METROPOLITAN GOVERNMENT OF NASHVILLE AND DAVIDSON COUNTY

STAFF RECOMMENDATION 1419 Calvin Avenue February 18, 2015

Application: New construction – infill and detached accessory dwelling unit; Setback determination

District: Lockeland Springs-East End Neighborhood Conservation Zoning Overlay

LEFT SIDE ELEVATION
SCALE: 1/4" = 1'-0"

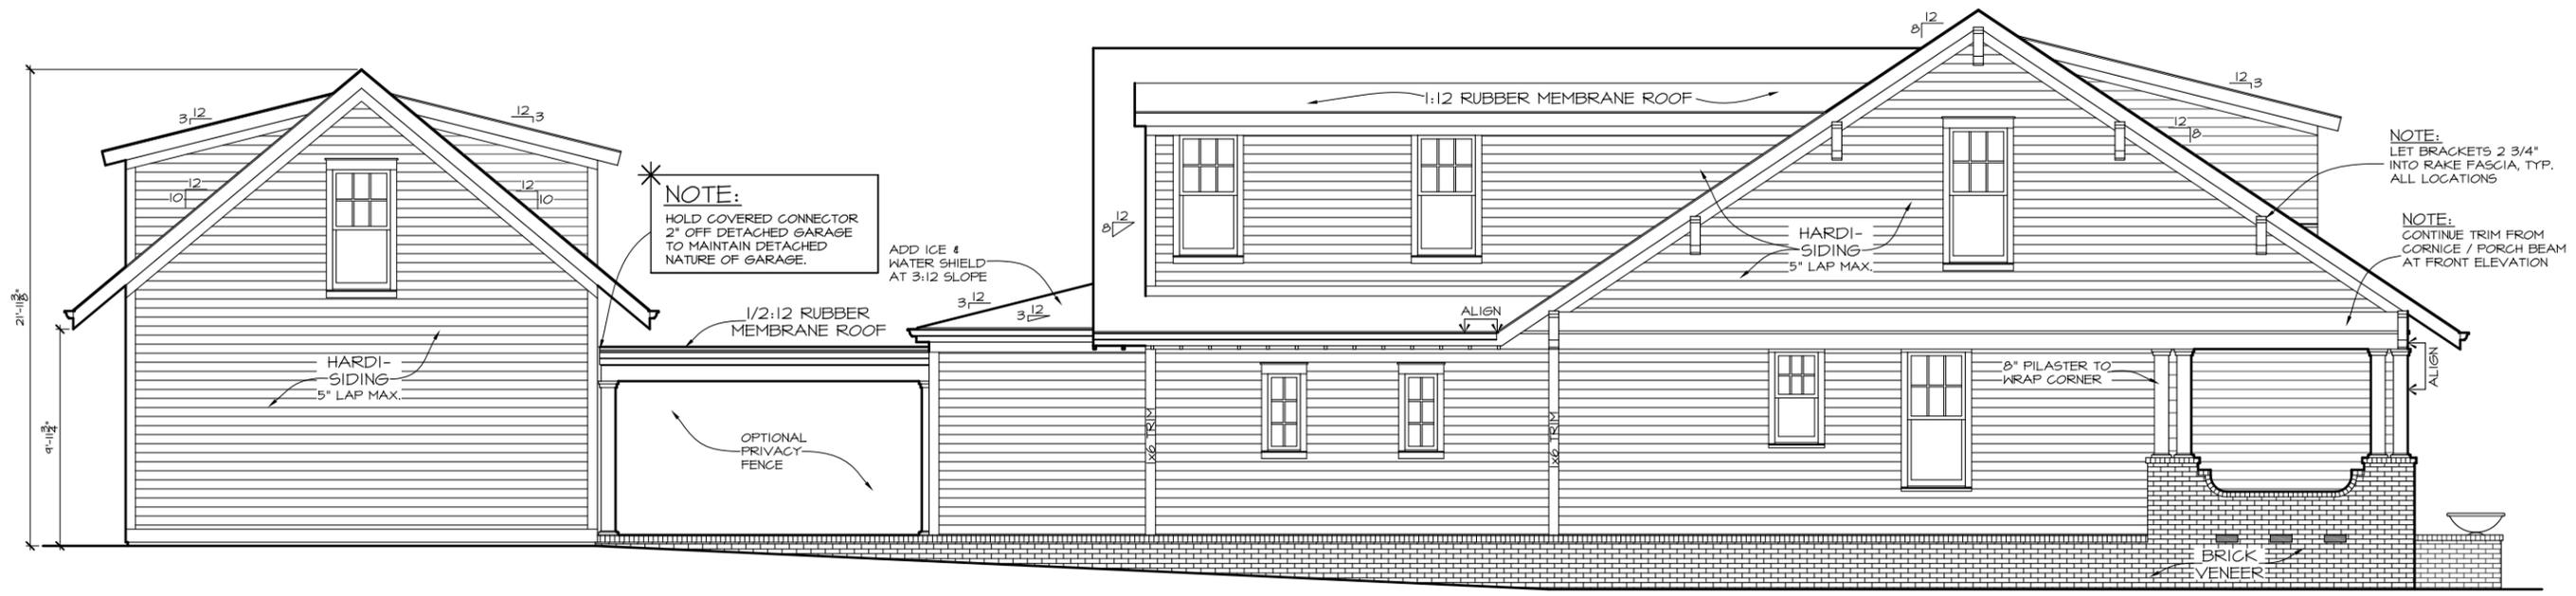
Roof form: The new house will have a side gabled roof with a pitch of 8/12. On the front slope of the roof there will be a shed dormer with a 3/12 pitch. The front dormer will sit four feet (4') back from the leading eave of the house. On the rear of the building, behind the primary side gabled component, there will be a rear facing gable with a pitch of 8:12. On each side of this gable there will be side-facing shed dormers. The outer walls of these dormers will sit directly over the side walls of the first story below. Typically, dormers are required to sit two feet (2') back from the front or side walls of the story below. With a condition that these dormers sit back at least two feet (2'), staff finds that the roofs of the new building would be compatible with those of surrounding historic houses, and that the project would meet section II.B.5.

- The side-facing dormers on the house sit at least two feet (2') back from the first story walls;
- Staff reviews and approves the final selection of windows and doors, with the front door being at least fifty percent (50%) glass; and,

FRONT ELEVATION
SCALE: 1/4" = 1'-0"

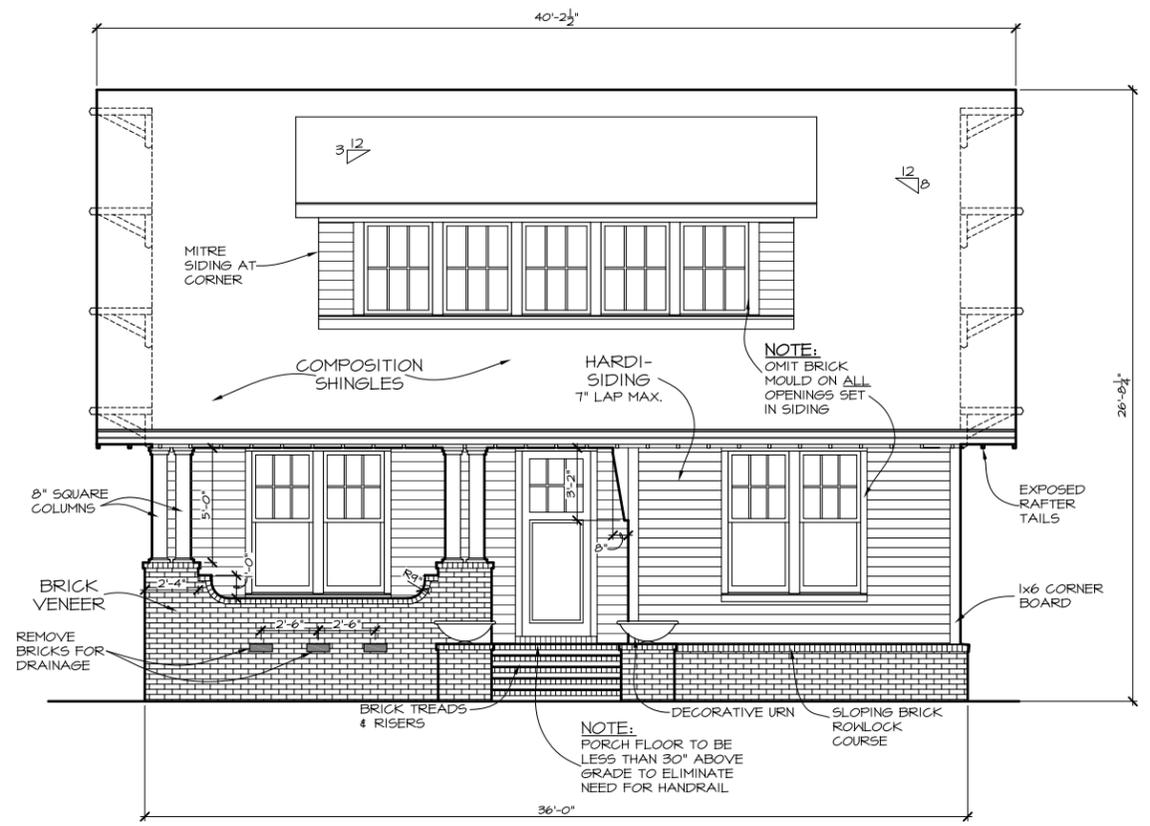
Height & Scale: The new house will be one and one-half stories, with a total height of twenty-six feet, nine inches (26'-9") from grade. The foundation height will be thirty inches (30"). From the finished floor level, the ridge height will be twenty-four feet, three inches (24'-3") inches and the eave height will be eight feet, six inches (8'-6"). Staff finds that the height is appropriate to the historic context, where the houses range in height from fifteen feet to twenty-nine feet (15' to 29') from grade.

The building will be thirty-six feet (36') wide at the front, with a twenty foot (20') wide by eight foot (8') deep recessed porch in the left side. The majority of houses in the surrounding area are between twenty-eight feet (28') and thirty-four feet (34') wide, but there are four comparable houses on the block that are thirty-seven feet (37') wide or greater, including the two directly across the street, on similarly-sized lots. The main portion of the new building will extend forty feet (40') back; a rear wing adds a further twenty-nine feet (29') in the manner of an addition. The total footprint of the building will be one thousand, eight hundred and seventy-four square feet (1,874 sq. ft.). The scale of the house is broken up, reducing the perceived massing of the house, and would have a similar massing to several historic houses in the surrounding area.

Proportion and Rhythm of Openings: The windows on the proposed infill are all generally twice as tall as they are wide, thereby matching the historic proportions of openings. The largest expanse of wall space without a window or door opening is approximately nine feet (9') toward the rear of the left side. Staff finds the project's proportion and rhythm of openings to meet section II.B.7.

- The finished floor height shall be consistent with the finished floor heights of the adjacent historic houses, to be verified by MHZC staff in the field;

SITE PLAN
1:20

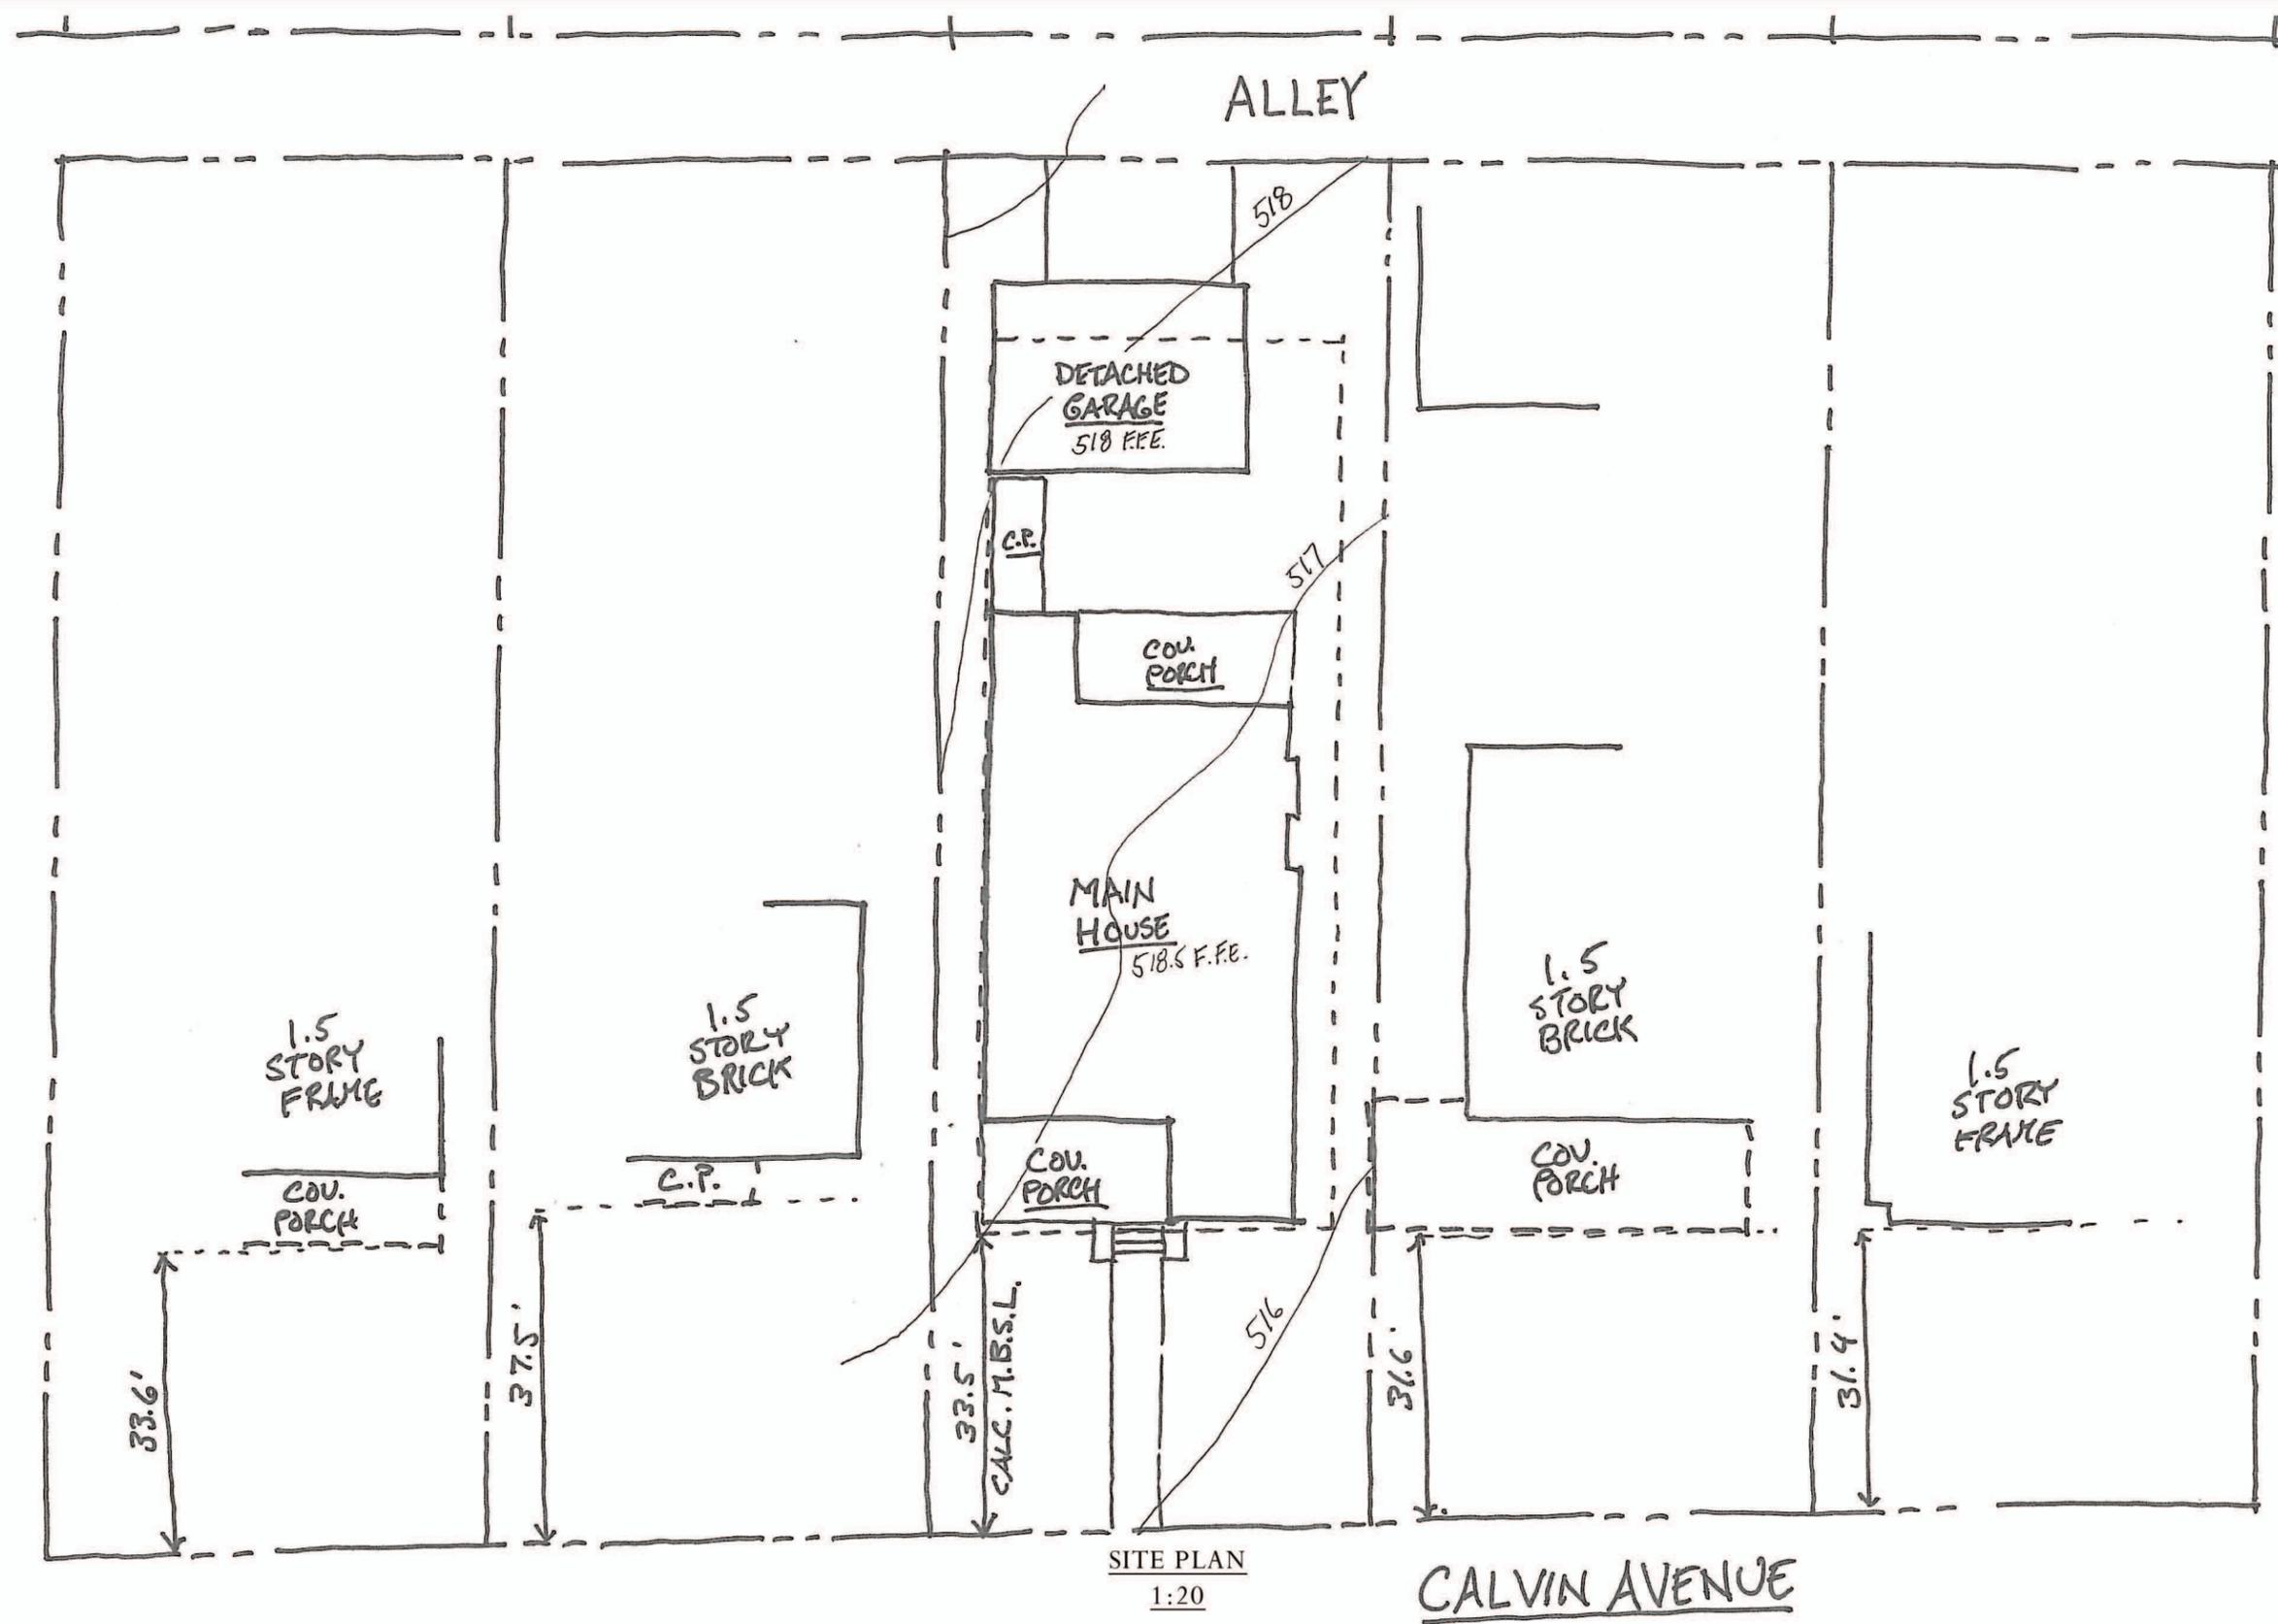
Setback & Rhythm of Spacing: The new house will sit thirty-five feet, six inches (35'-6") from the front of the property, which is the average of the front setbacks for the adjacent historic houses. The house will be nearly centered on the lot with side setbacks

of six feet (6') on the left side and eight feet (8') on the right. These setbacks are similar to those found on historic houses nearby, and will maintain the rhythm and spacing established by existing houses on the street. The project meets section II.B.3.

Location: The design guidelines require that outbuildings be located in the established rear yard behind the principal building, and be at least twenty feet (20') from the principal building. The proposed outbuilding would be behind the house; however, it would only be fifteen feet (15') away from the principal building. The proposed outbuilding would not meet this guideline. Moving the building five feet (5') to the rear would meet this guideline, and result in an eight foot, six inch (8'-6") rear setback, which would be an appropriate setback for an outbuilding. This condition would require a

setback determination for the rear setback. A covered walkway is drawn connecting the rear of the house to the outbuilding. As it is only six feet (6') in width, and will be a minimal connection to the house, Staff finds the covered portion is appropriate here. The side setbacks would be six feet (6') on the left and fifteen feet (15') on the right. The side setbacks are appropriate.

- A restrictive covenant on the detached accessory dwelling unit is filed prior to issuance of the permit (This is a requirement of the ordinance.);
- The detached accessory dwelling unit is separated from the principal building by at least twenty feet (20');
